NOTICE OF DECISION

Friendsview Springbrook Meadows II – Design Review – DR220-0005

<p>DECISION AND FINDINGS Friendsview Springbrook Meadows II – Design Review – DR220-0005</p>

REQUEST: Design Review of an independent senior living community consisting of 14 duplex units and expansion of an existing Community Center building

AKS DRAWING FILE: 5680_P04 - SITE PHASING PLANNING | LAYOUT: P04

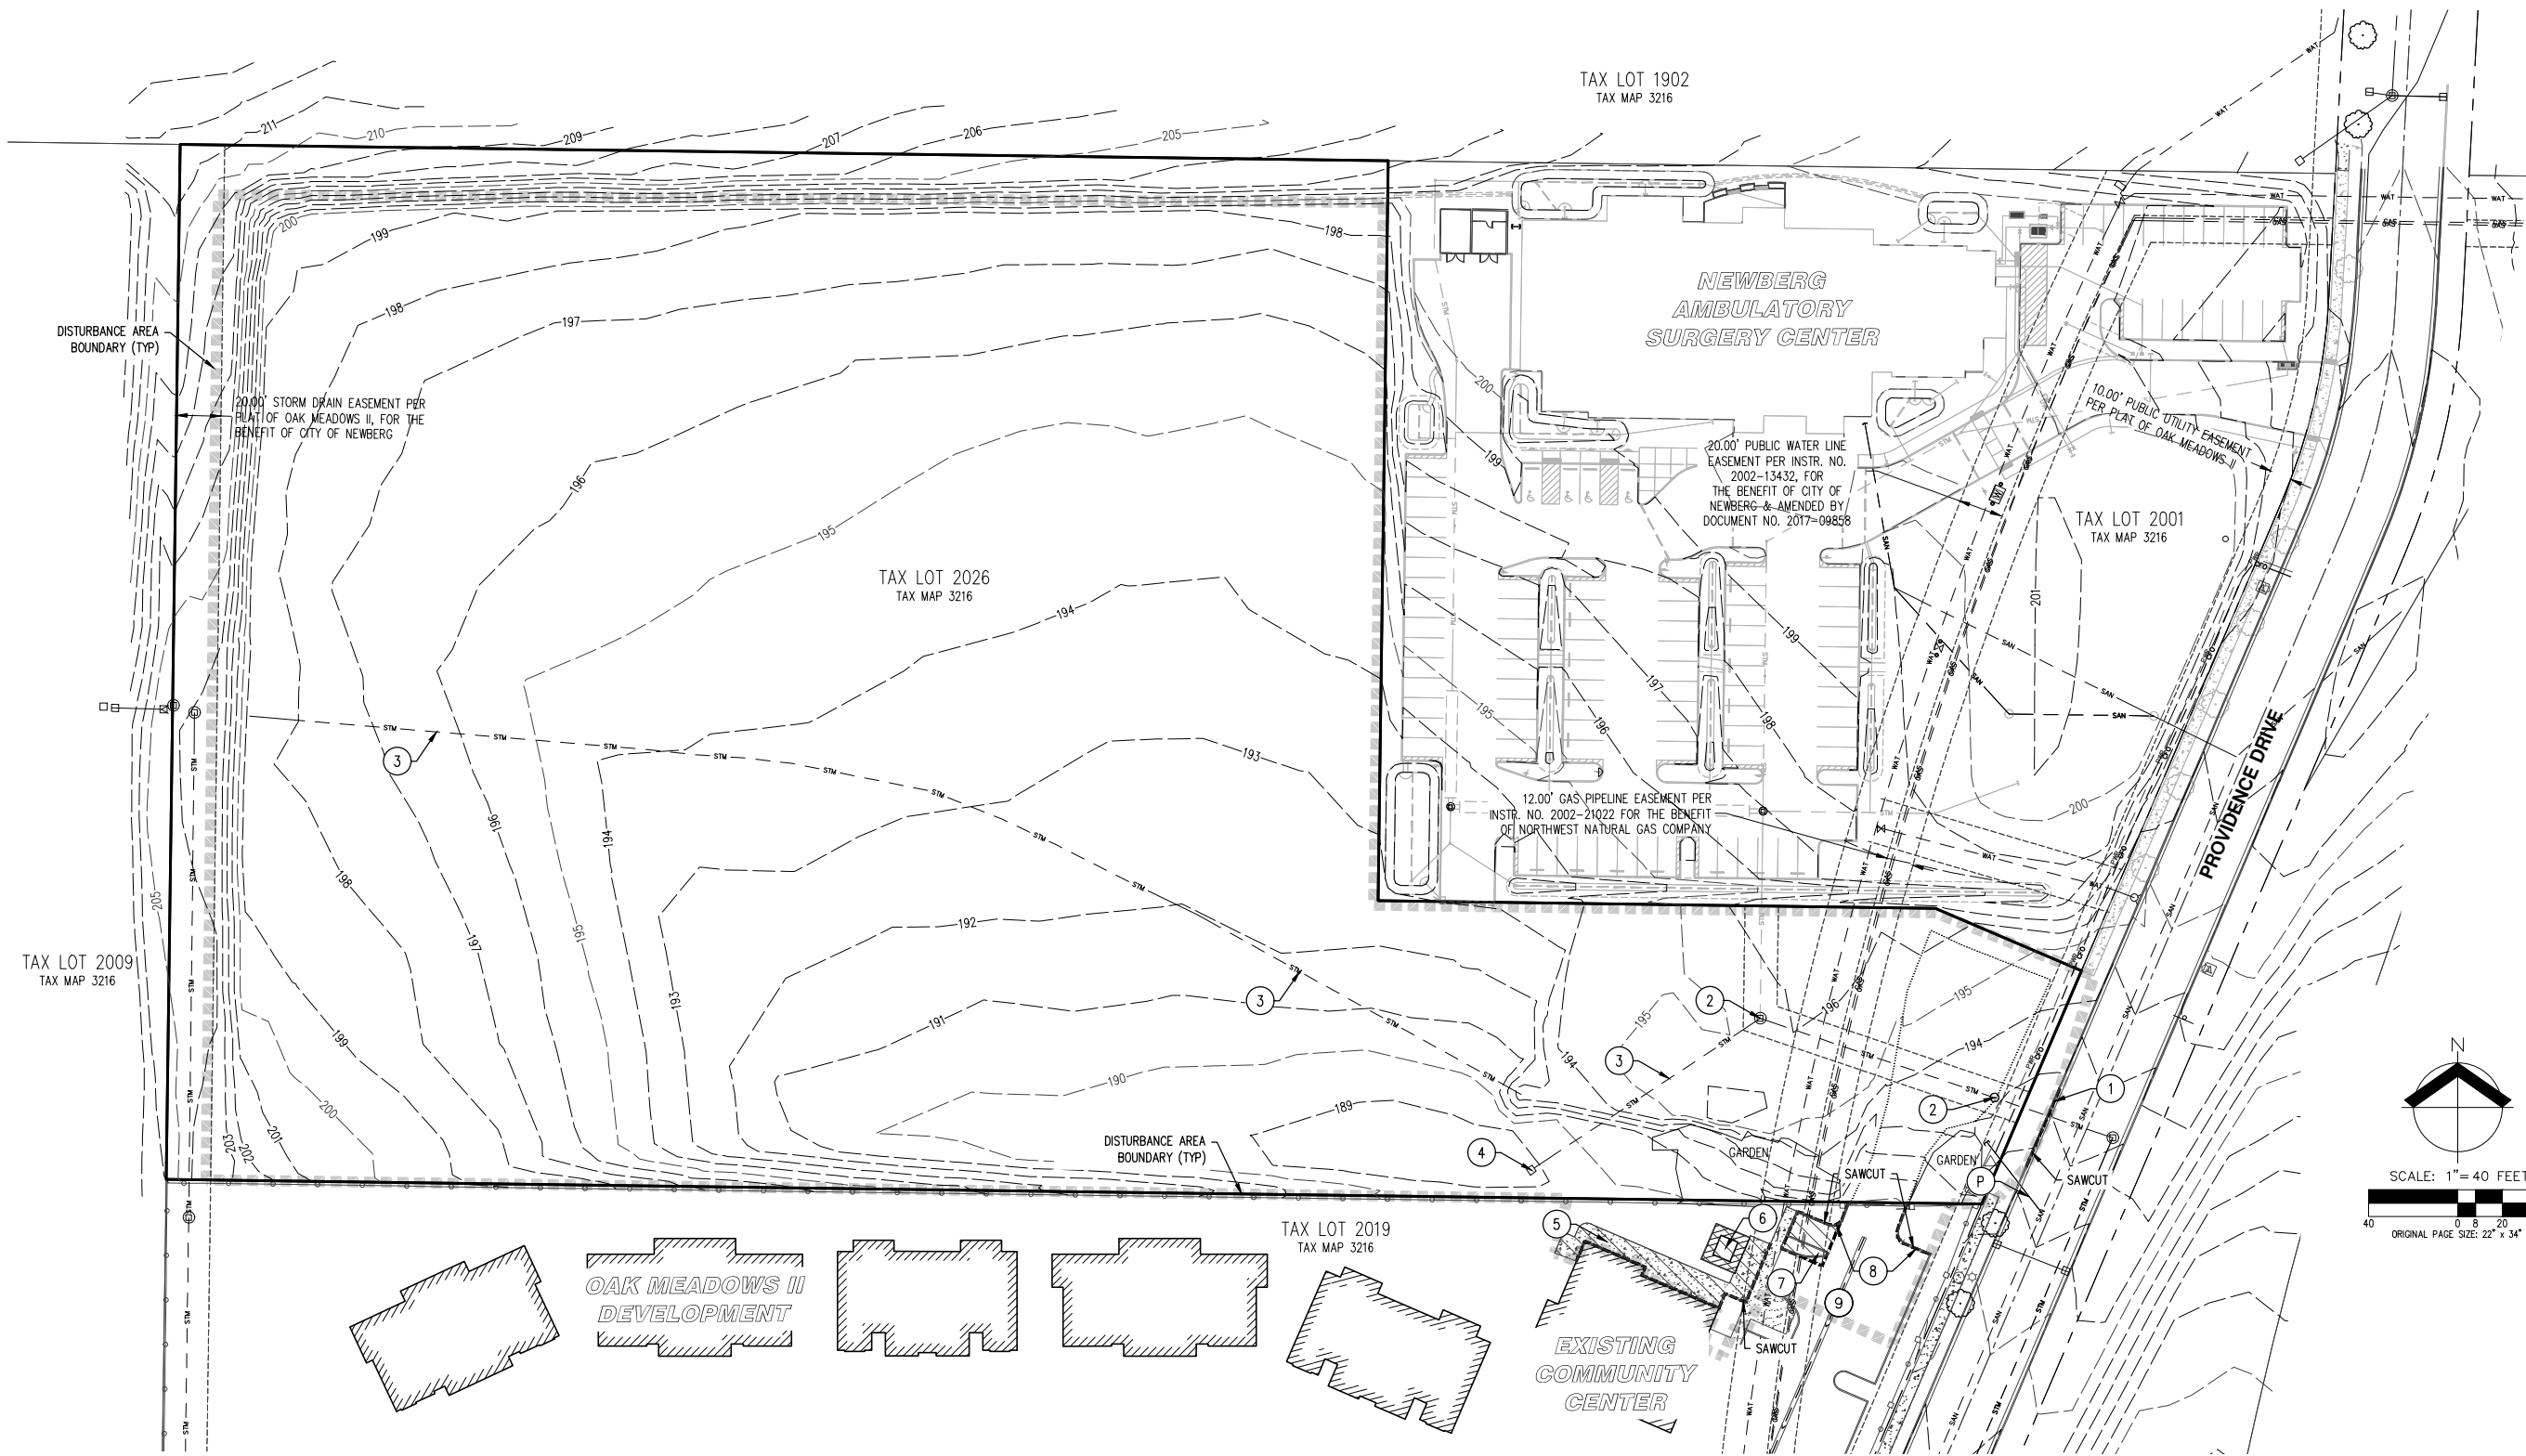
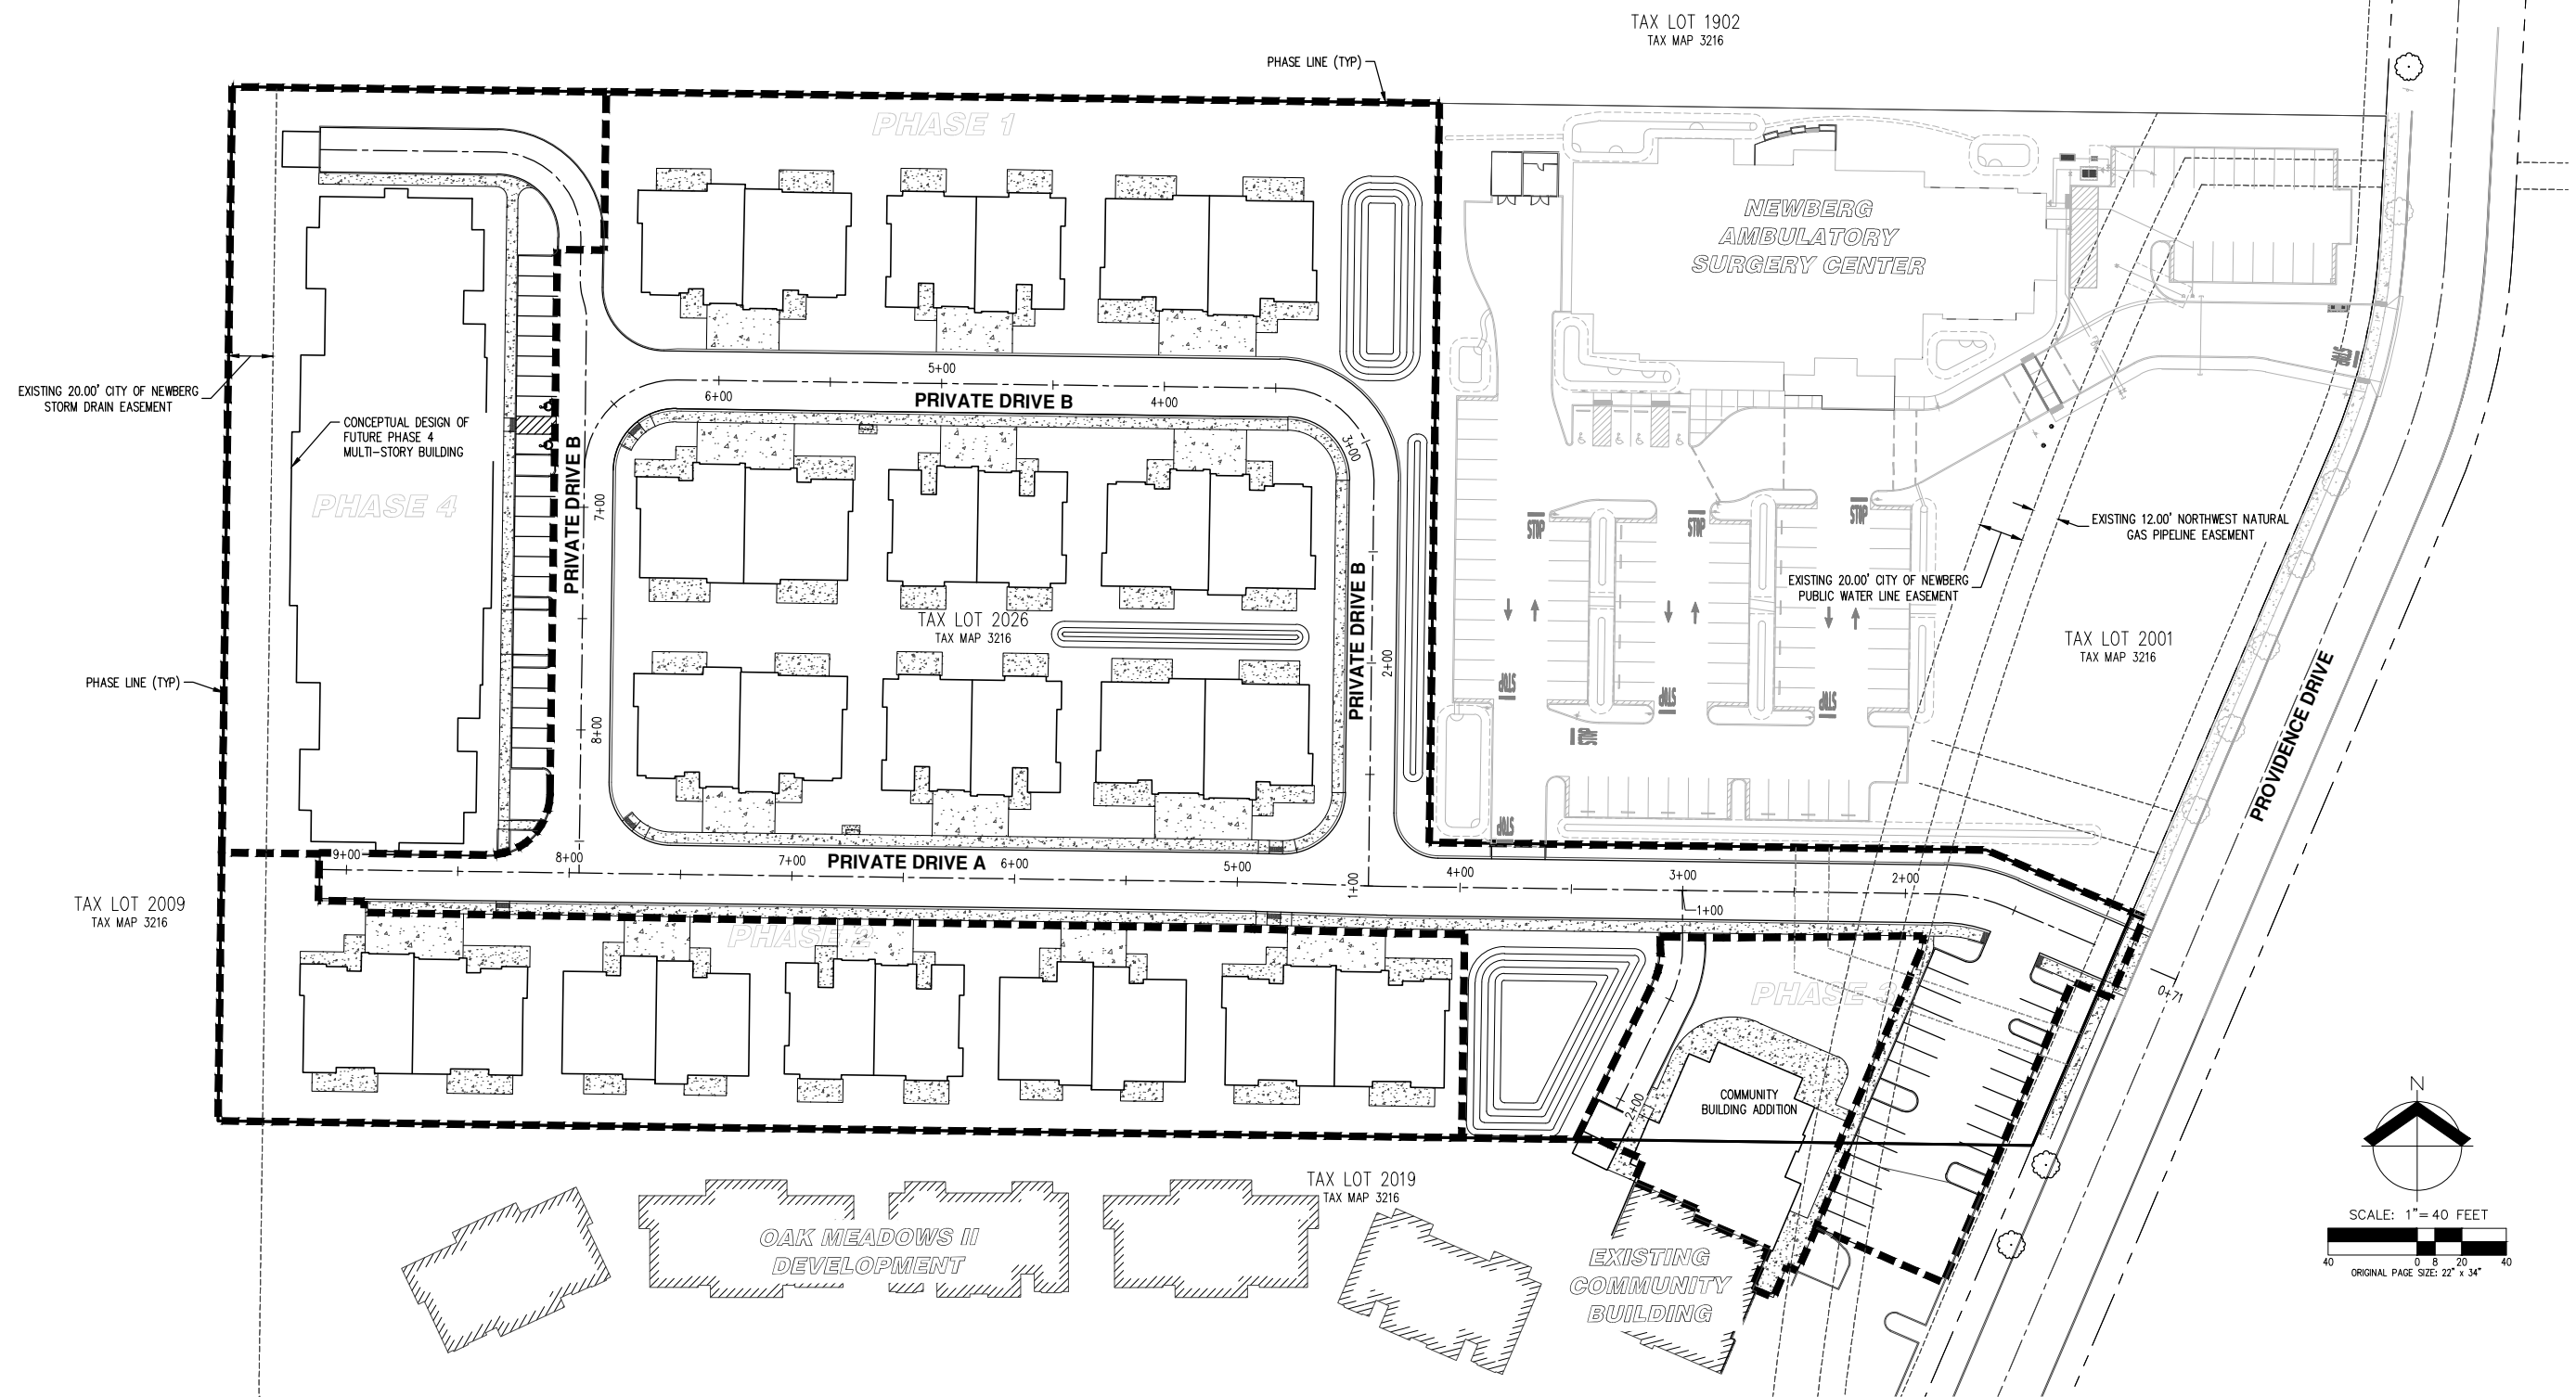
Sheet P04 of the applicants' plans shows four phases of development, with the first three phases being reviewed for this design review application. The development will construct a looped private driveway for internal vehicle circulation as part of Phase 1 construction. Both Phases 1 and 2 will involve construction of the duplexes. Phase 3 will involve expansion of the existing community building over the consolidated property line, land use file PLC20-0004, along with sidewalk and 17 additional parking spaces along the eastern portion of the development site. The applicant has also stated in their narrative that one side of the private looped driveway will allow on-street parking. Plan Sheet P06 shows a 24 foot drive aisle, parking spaces dimensioned at 9 feet by 18 feet facing toward N Providence Drive and 9 feet by 20 feet on the west side of the drive aisle for the Community Center.
